ADDENDUM NO. 2

**TASMG READINESS CENTER
AVCRAD Facility
Springfield, Missouri
PROJECT NO.: T1809-01**

Bid Opening Date: 1:30 PM, Thursday, May 21, 2020 (Not Changed)

May 7, 2020

1 FIRST FLOOR POWER PLAN - AREA B
1/8" = 1'-0"

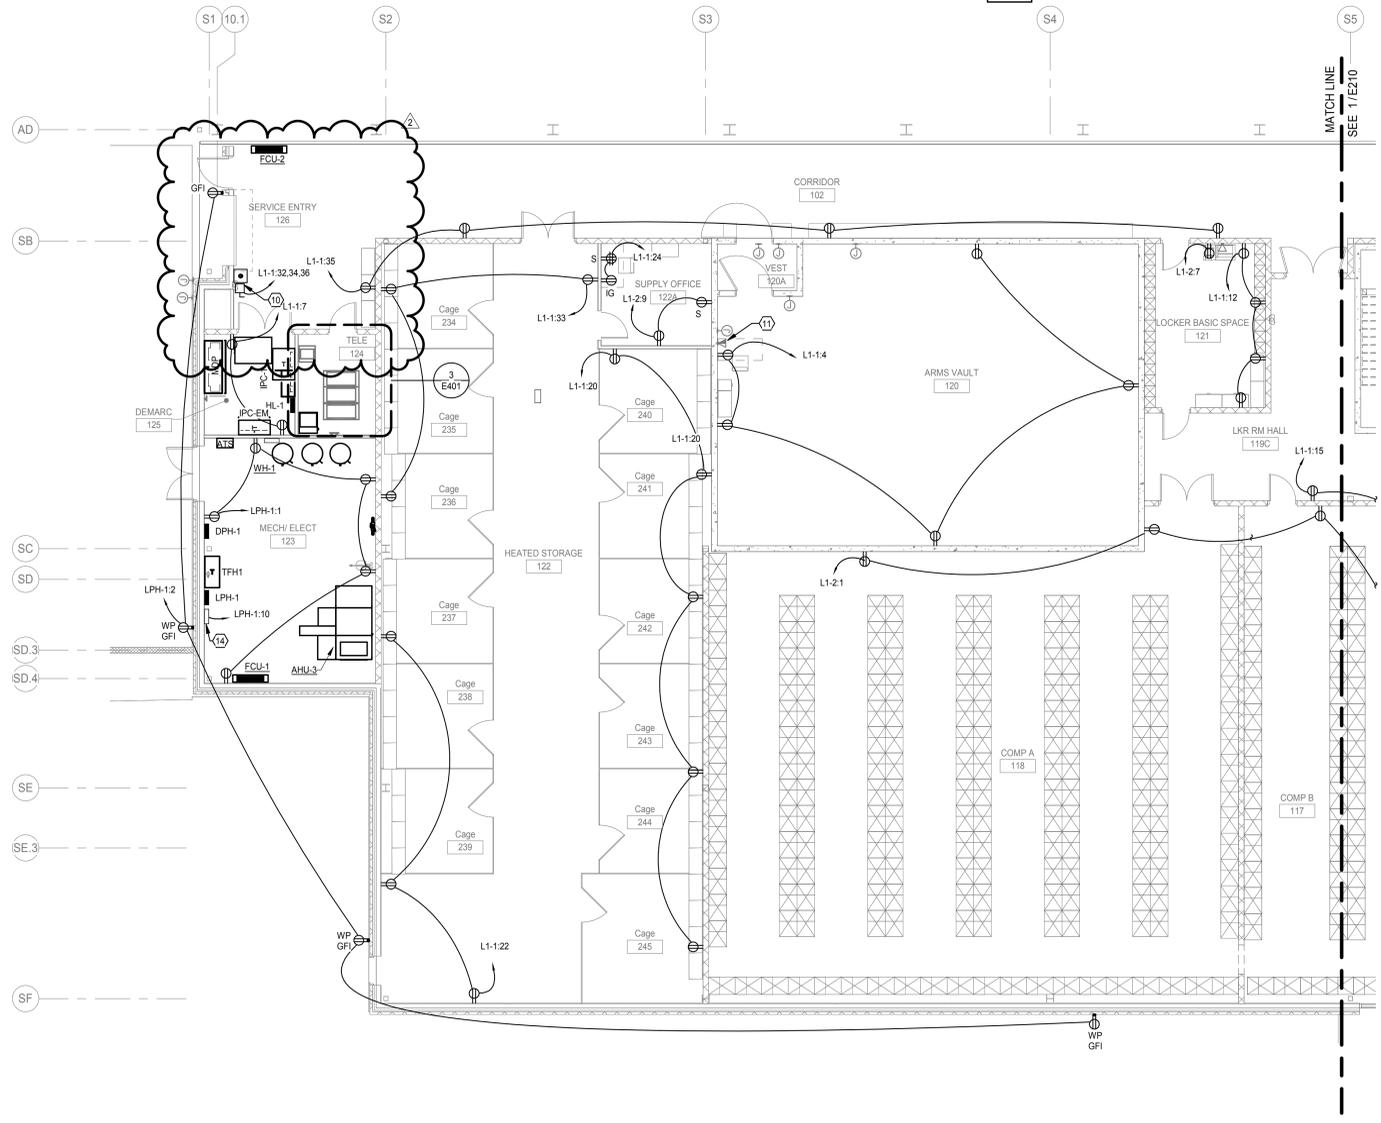
11. Sheet E211 – FIRST FLOOR POWER PLAN – AREA B

- a. See attached revised Sheet E211 – FIRST FLOOR POWER PLAN-AREA B for changes to power locations related to loading dock wall adjustments.
